TECHNICAL NOTE RESPONDING TO COMMENTS RAISED BY WOKINGHAM BOROUGH COUNCIL ENVIRONMENTAL HEALTH IN RESPECT TO THE PROPOSAL TO REMOVE CONDITION 32 (REF 241926) AT HEADLEY ROAD EAST, WOODLEY

The purpose of this Technical Note is to respond to comments raised by Wokingham Borough Council Environmental Health in response to the proposal to remove Condition 32 of Appeal Reference: APP/X0360/W/22/3306963, dated 22nd December 2023, through Section 73 of the Town and Country Planning Act, 1990. The proposal is to remove the restriction on the permitted hours of deliveries such that deliveries can be accepted or dispatched from Units 9 and 10 throughout the night-time period (2300 hrs to 0700 hrs). The comments received as detailed in a memorandum dated 8/8/2024 and corresponding ACCON responses are detailed below:

Figure 1: CadnaA Screenshot (Facing North from a 5m Height)

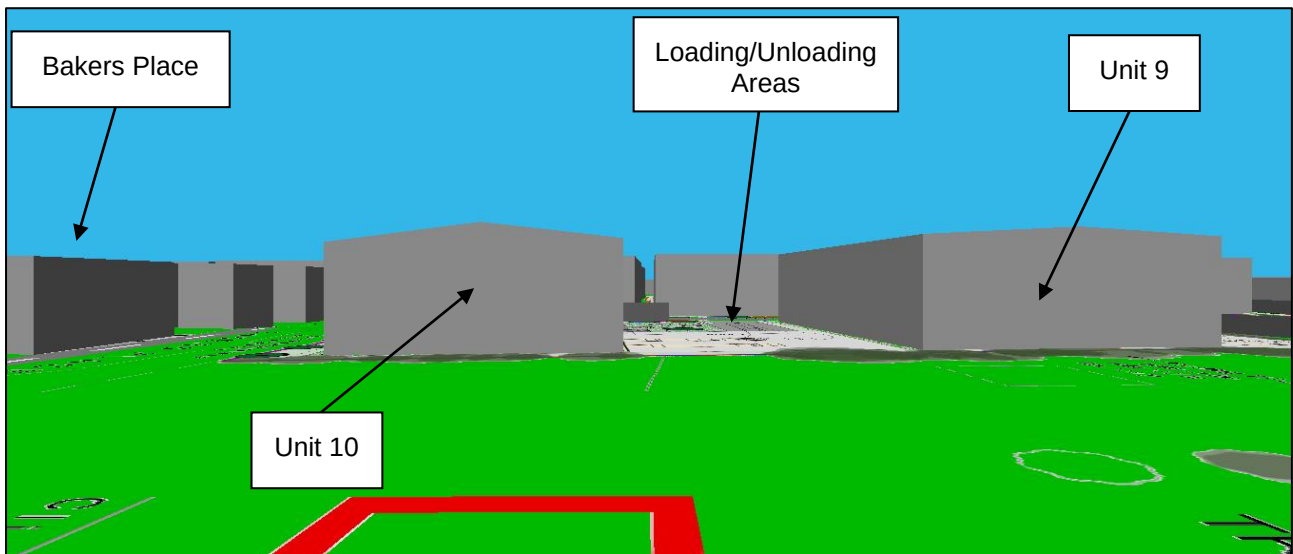
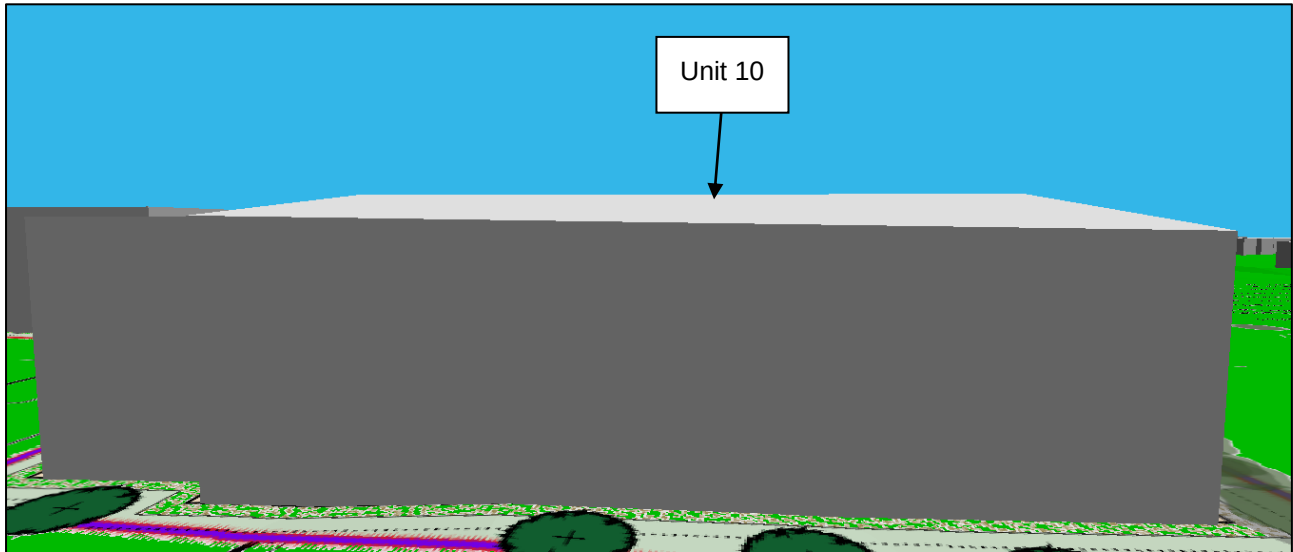
3) The NSR (nearest sensitive receptor) for noise for unit 10 is shown as Lilly May Court, there are some other residential properties also in close proximity to the expected loading area for unit 10 along Bakers Place, are these considered to be shielded from loading unloading noise by the fabric of the building? In which case can a drawing clearly defining this and showing the expected loading unloading area(s) be presented and the reasoning shown in the report.

Figures 1 and 2 illustrates screenshots from the CadnaA Noise modelling software that depict Bakers Place in relation to Units 9 and 10, and the Loading/Unloading areas.

Figures 1 and 2 illustrate that Bakers Place lacks a direct line of sight to the loading and unloading areas, which are located approximately 50 metres from the eastern façade of Bakers Place. Additionally, the proposed Unit 10 has a ridge height of 11.2 metres and will extend approximately 3.2 metres above the second floor of Bakers Place. This will effectively act as a significant noise barrier, mitigating against any noise emanating from the loading and unloading bays.

Figure 3: Location of Air Conditioning Unit

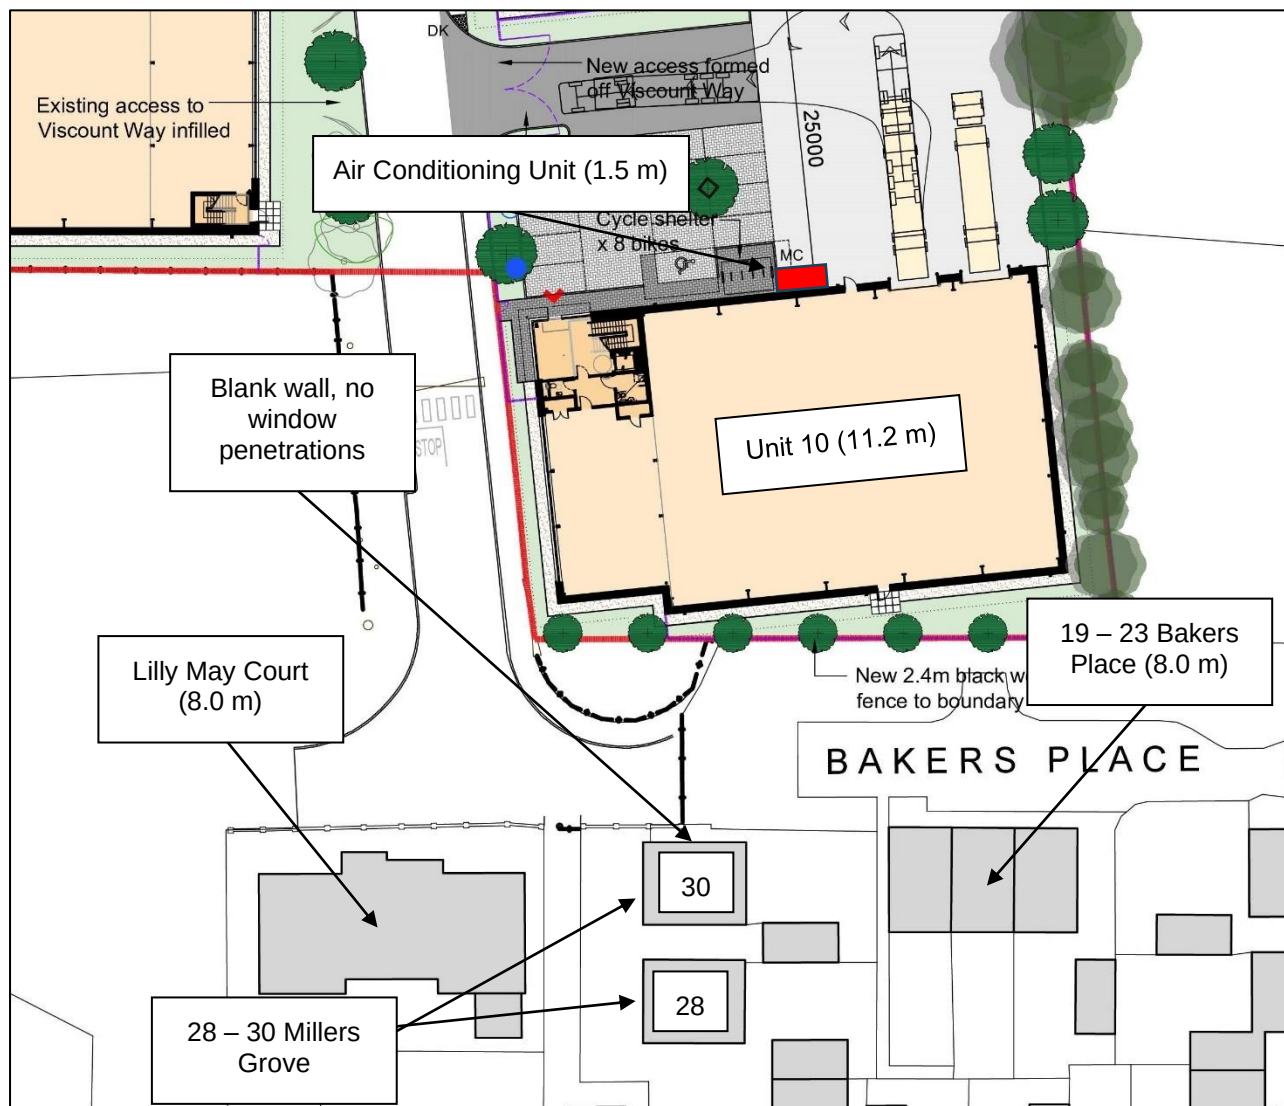
4) Is there any plant involved in this proposal to change operating hours for units 9 and 10 that is not currently running at night, this would be inclusively assessed in a BS4142 assessment.

Figure 3 below identifies the location of the air conditioning unit, highlighted in Red, relative to Unit 10, and the NSRs at Lilly May Court and Bakers Place. This air conditioning unit is the only proposed plant that will be running during the night-time period (2300 hrs – 0700 hrs). The corresponding heights of the air conditioning unit, Unit 10, and the NSRs are also identified.

Figure 3 demonstrates that Unit 10 provides significant shielding, ensuring that the air conditioning units operation has no noise impact on the NSRs at Lilly May Court, Bakers Place and Millers Grove. This is due to there being no direct line of sight between either any NSR and the air conditioning unit. Therefore, the air conditioning unit will have no adverse noise impact on the NSRs at Lilly May Court, Bakers Place and Millers Grove.
